Magnolia Public Schools

Ad-Hoc (Facility) Committee Meeting

Approval of Change Order Requests by Oltmans Construction Co. for MSA-1

Ad Hoc Committee Agenda Item #:	II A – Action Item
Date:	December 4, 2019
To:	Magnolia Educational & Research Foundation dba Magnolia Public Schools (“ MPS ”) Ad Hoc Committee (the “ Committee ”)
From:	Alfredo Rubalcava, CEO & Superintendent
Staff Lead:	Patrick Ontiveros, General Counsel & Director of Facilities
RE:	MSA-1 Change Order Requests

SHEET TITLE :	SECOND FLOOR H.V.A.C. PLAN
PROJECT :	MAGNOLIA SCIENCE ACADEMY 18220 SHERMAN WAY RESEDA, CA 91335
OWNER :	
DATE :	03-04-19
SCALE :	AS NOTED
DRAWN BY :	--
CHECKED BY :	--
JOB NUMBER :	18-3023
SHEET NUMBER :	SD-3.0

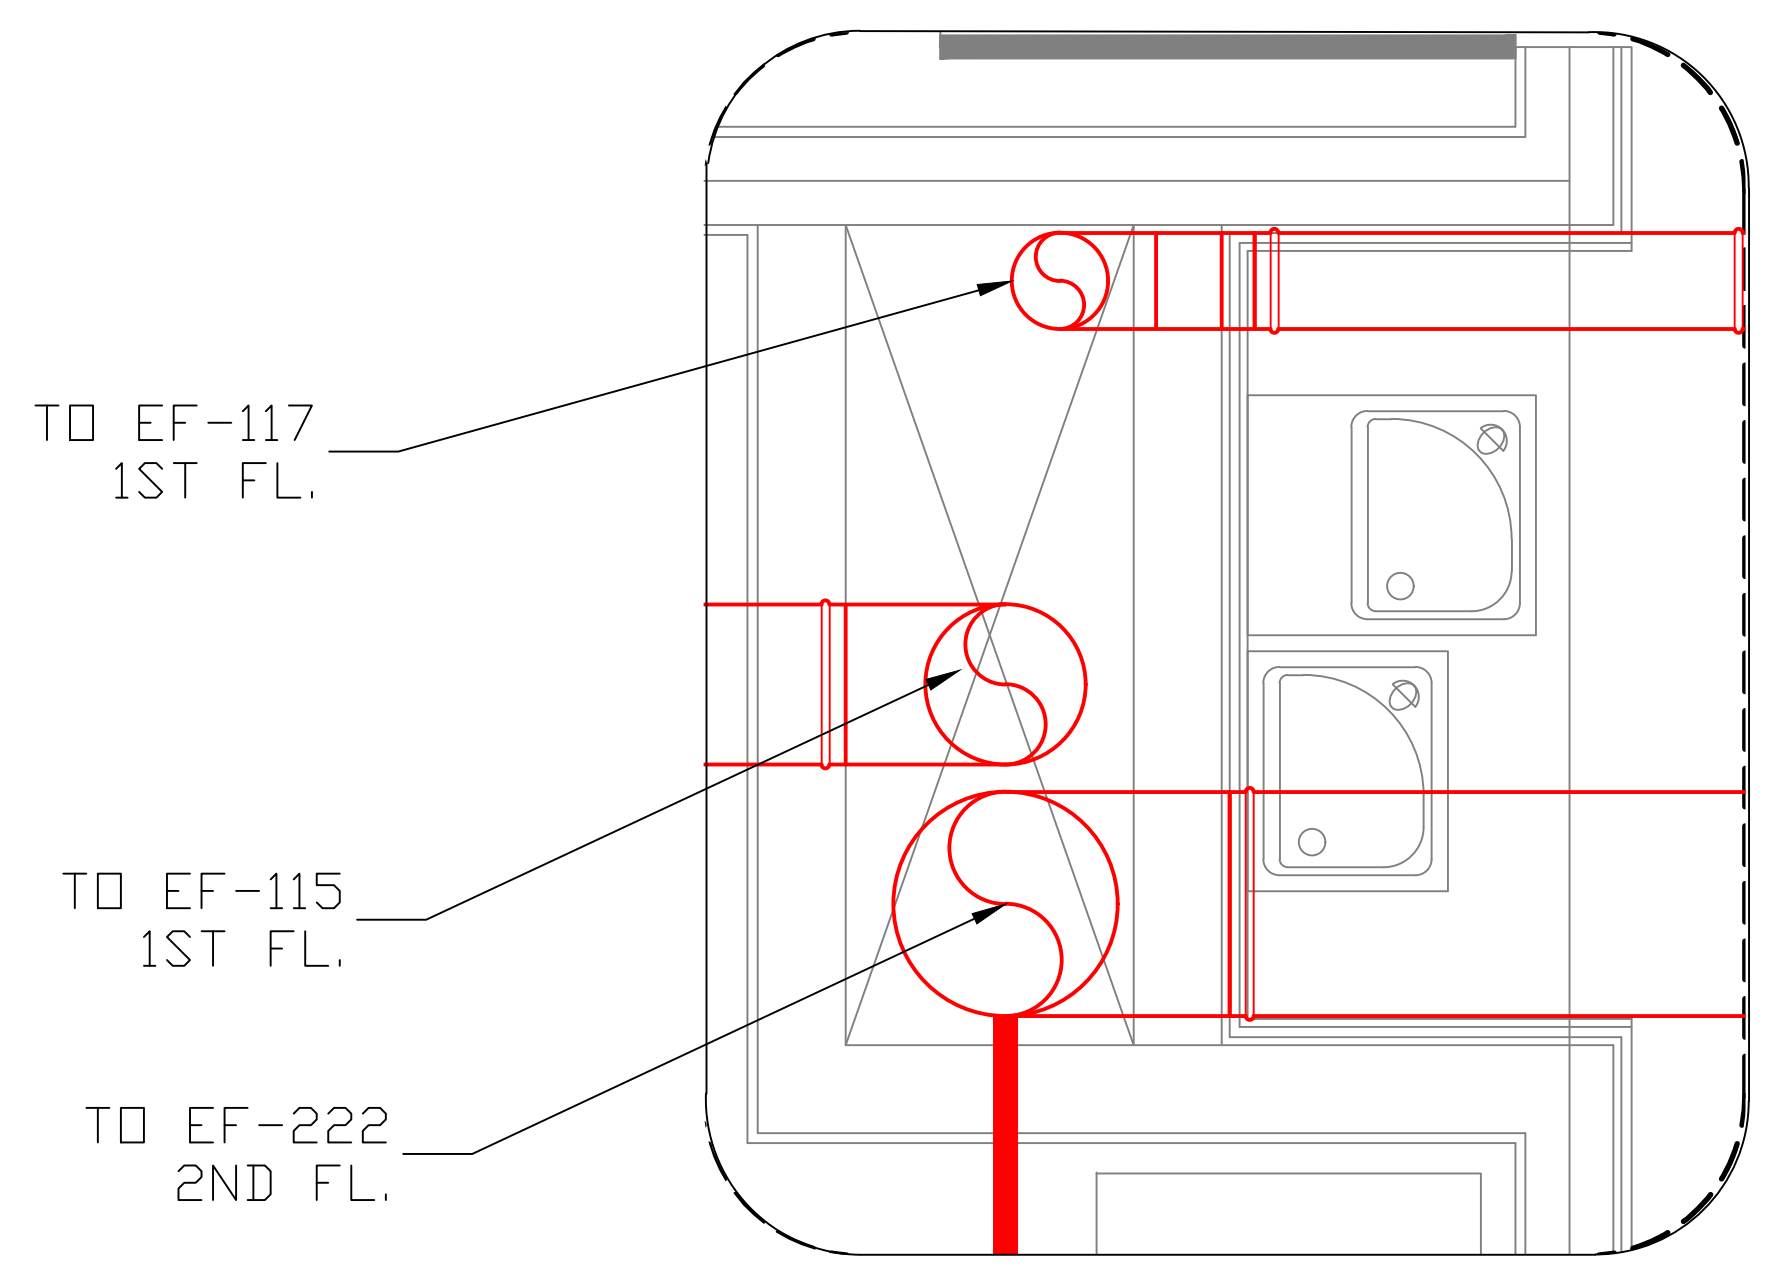
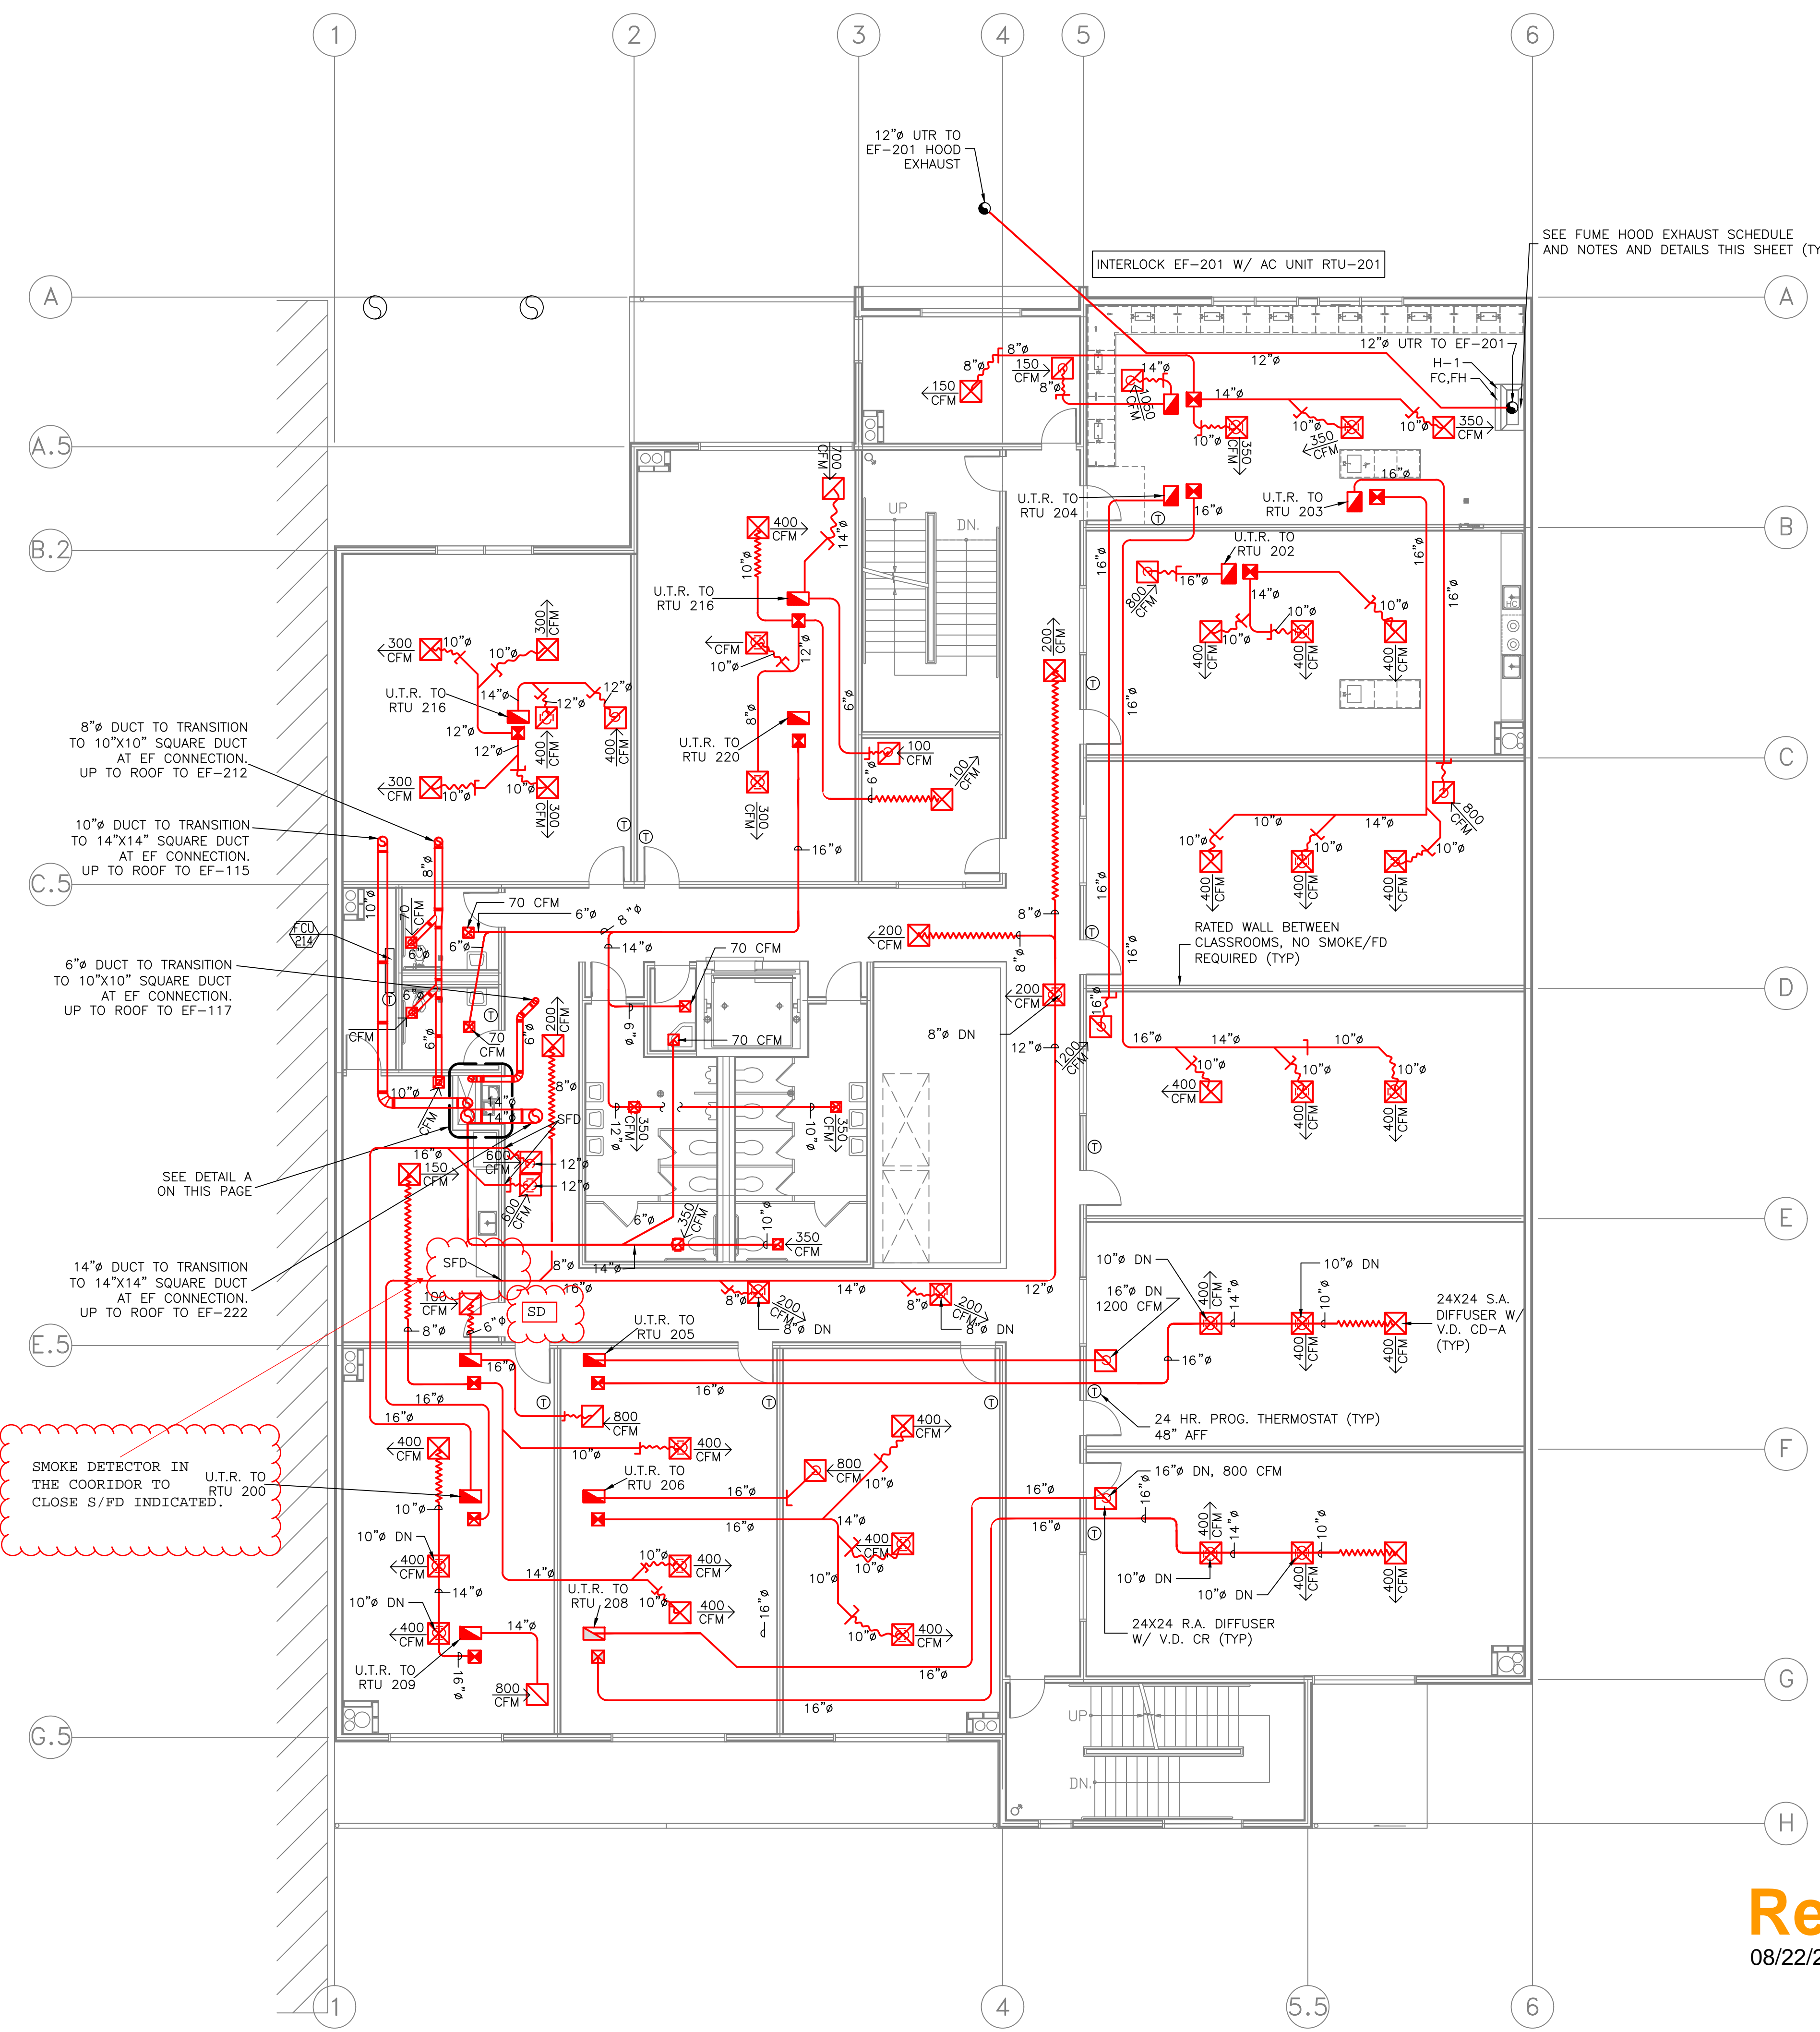
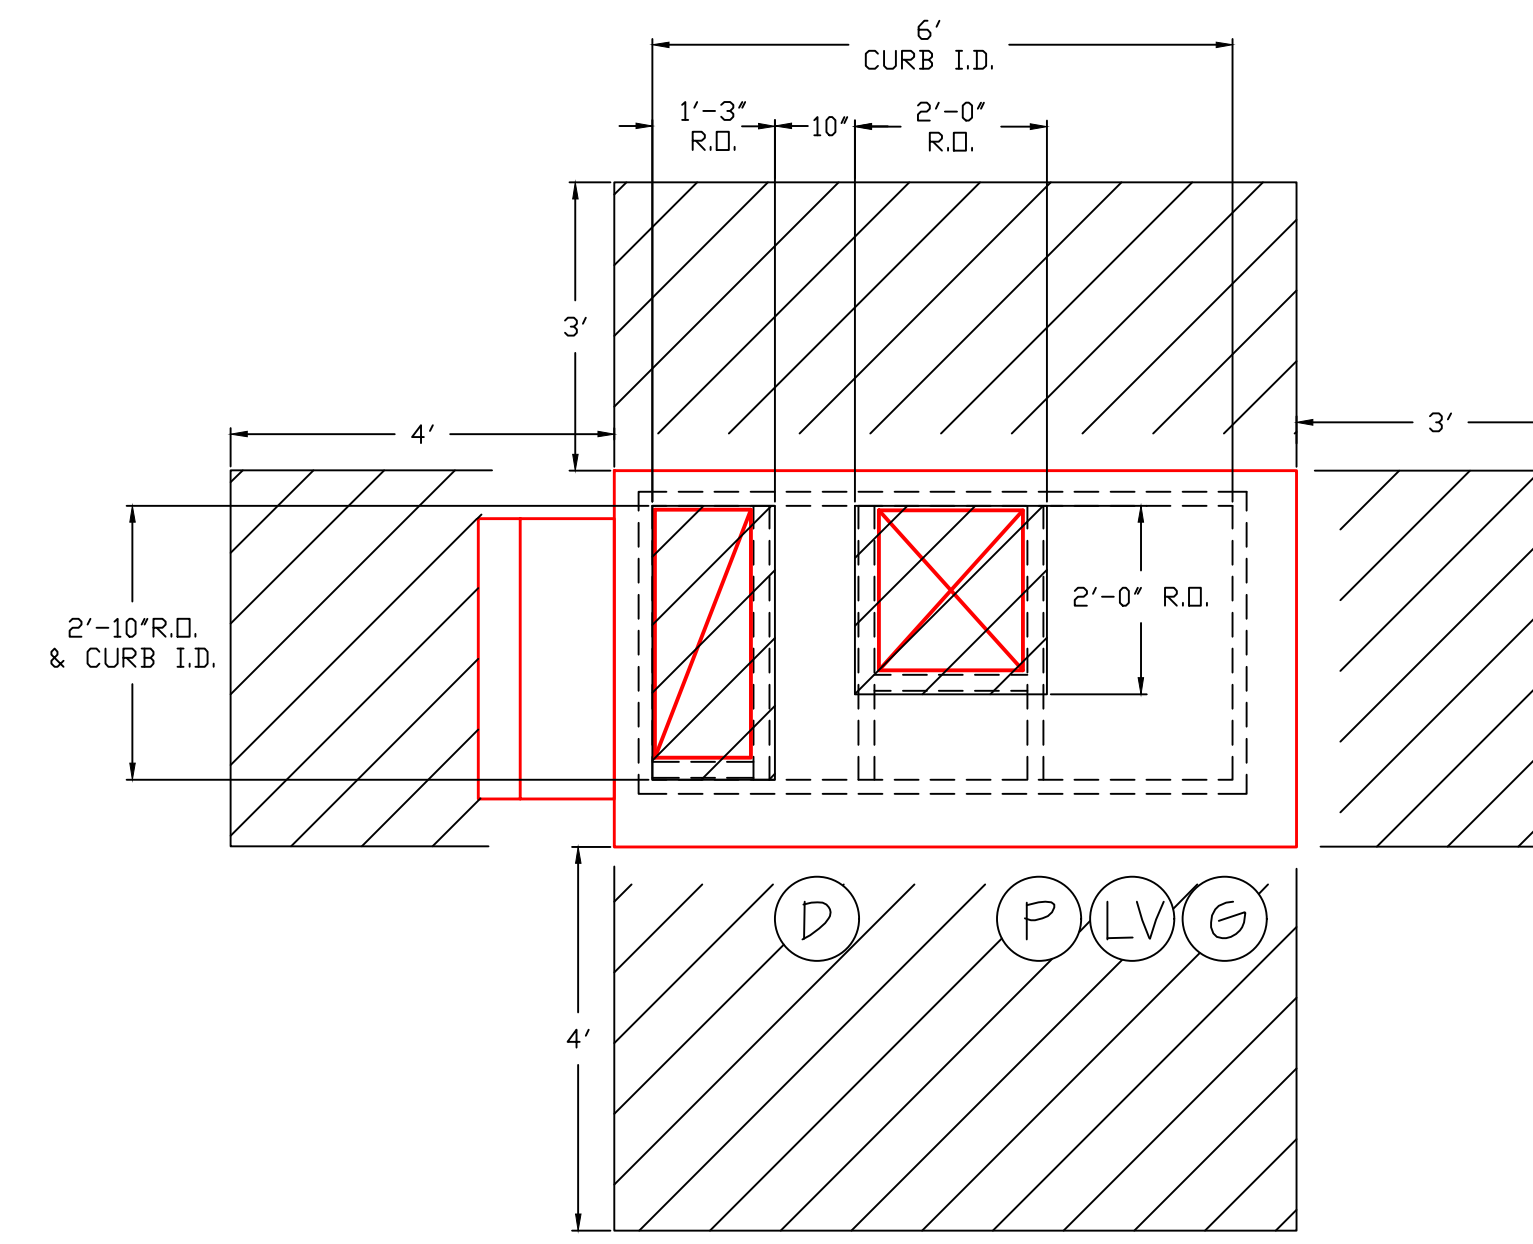
1. From shop drawing SD-2.0, rooms 100,101,102,103,104,110,1109,112,113,114. From shop drawing SD-3.0, 1 smoke detector is required within five feet of the smoke/fire damper shown on the plan I've attached and the s/fd clouded.
2. Shut down all the units as indicated in 1.
3. Duct detectors are not required.
4. Yes, on the second floor SD-3.0, near kitchen, see clouded.
5. Yes.
6. Only in room 109. return air from any of the other room will reach rm. smoke detector.
7. Smoke detector in corridor, second near kitchen will suffice.
- Date:** 8. Confirmed. Please verify with electrical.

RFI #160 PROPOSED LOCATION

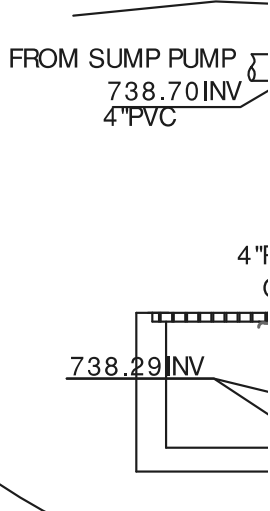
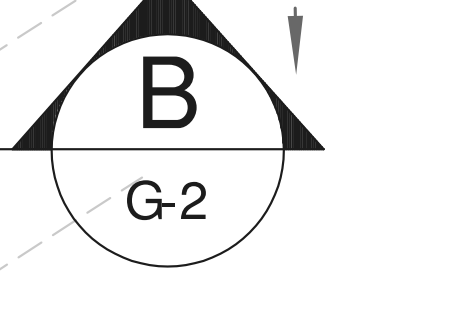
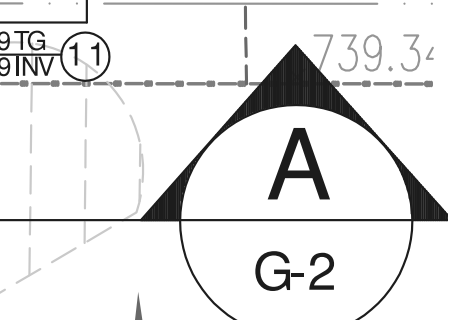
NOTE BY OCCO: Attachments provided by Franco Architect in response to RFI #160 include original sketch sent by OCCO part of G-2, and electrical drawings as referenced above include sheet E0.2, E.2.2.

1 WEST WALL

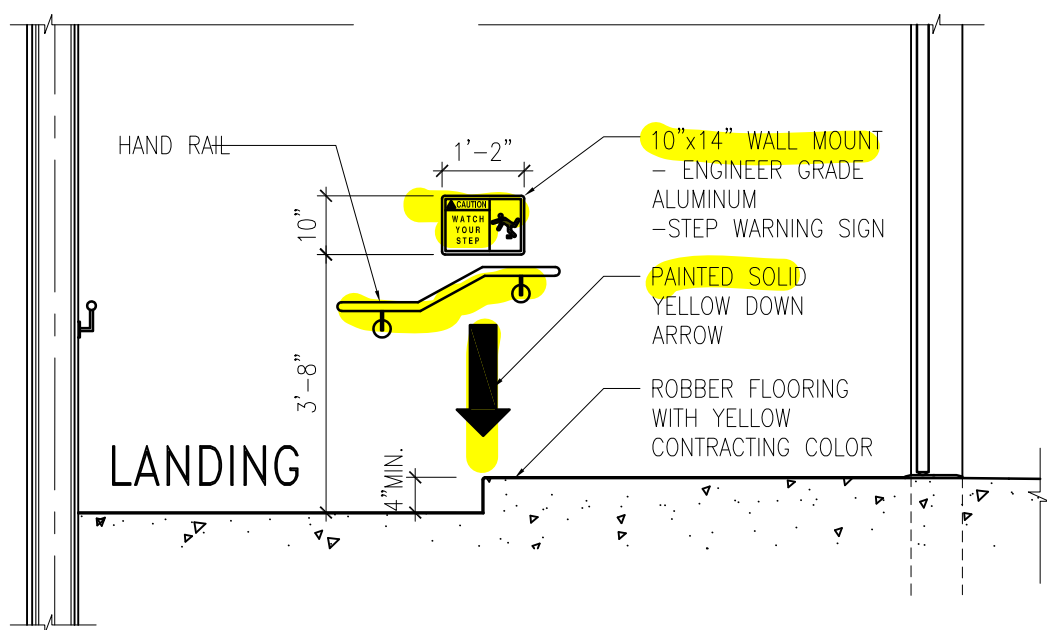
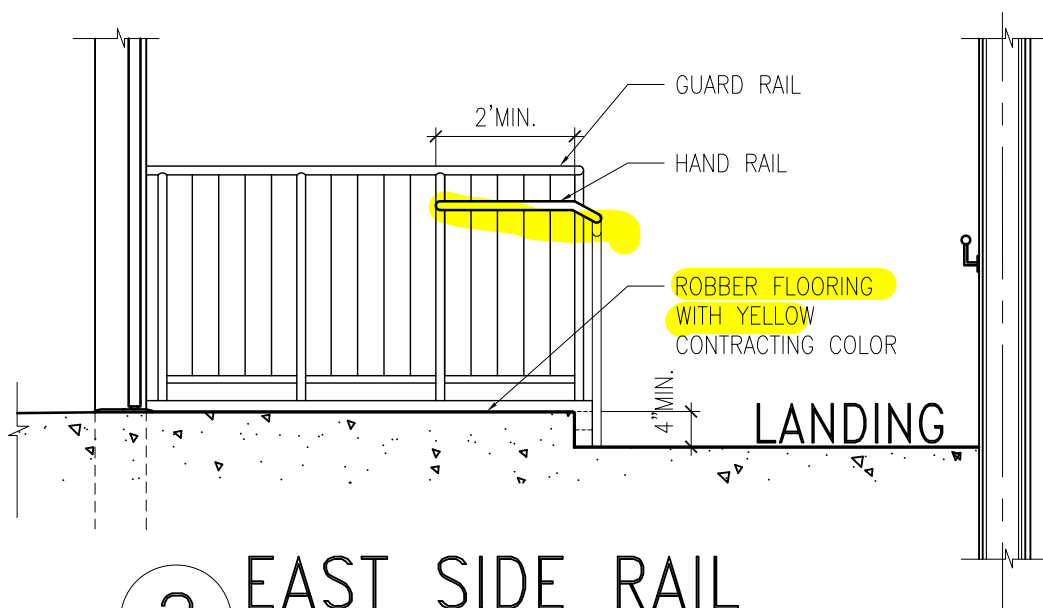
1. OCCO is to provide a color change at landing (stair #2, roof top only) due to added step. Such as warning tape or tread cover in safety yellow or contrasting color.
2. Add a small railing (on the wall side) by landing step, due to added step (stair #2, roof top only) .
3. Adjust hand railing at the landing due to added step (stair #2, roof top only) on the previously approved shop drawing 051200-03 Stairs Shop Drawings FAC 071018.

Add hand rail & backing per jobsite walk after OAC 5/8/19.

Change hand rail & backing per jobsite walk after OAC 5/8/19.

8/A9.3 - RFI 173 Chem Lab #201

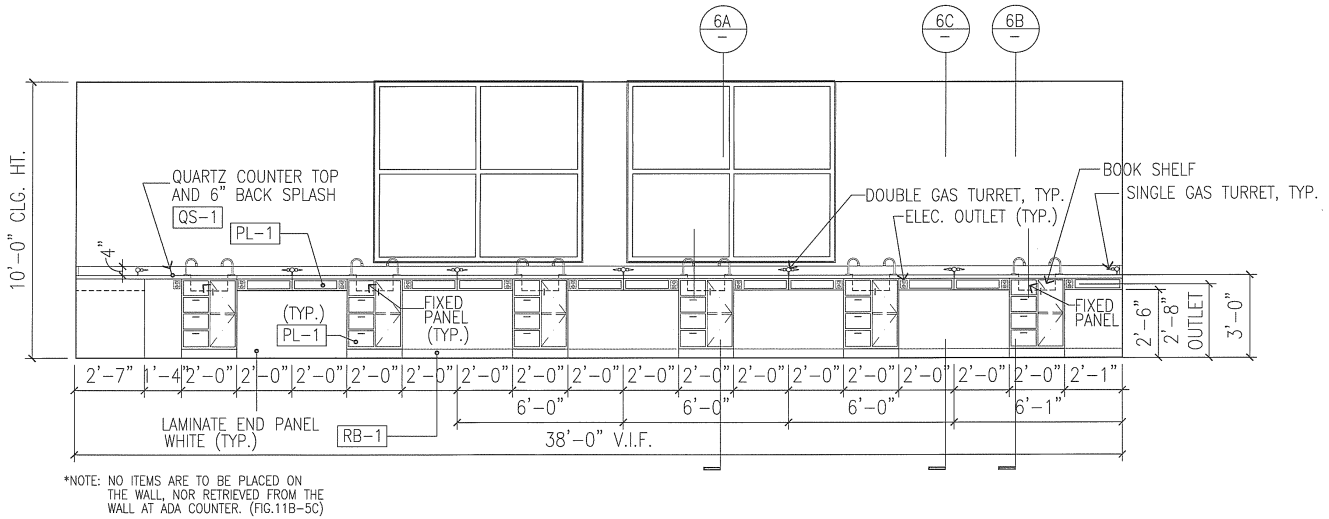
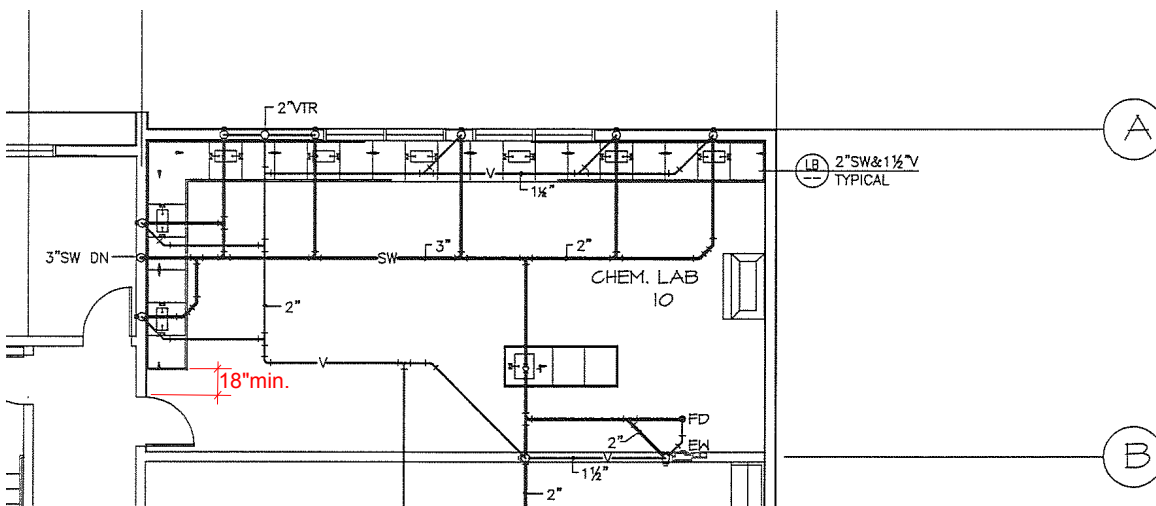
The Chemistry Lab room #201 has full height windows facing North above the lower cabinets. See A9.3 detail 8. The windows are type "A" found on A10.1. The plumbers have no way to run their waste and vents. We have large structural beams above and below. The 18" cavity between the windows are full of structural posts etc. There is no room to run a vent or waste up or down this 18" cavity.

Adjust the cabinet work at the north-west corner.
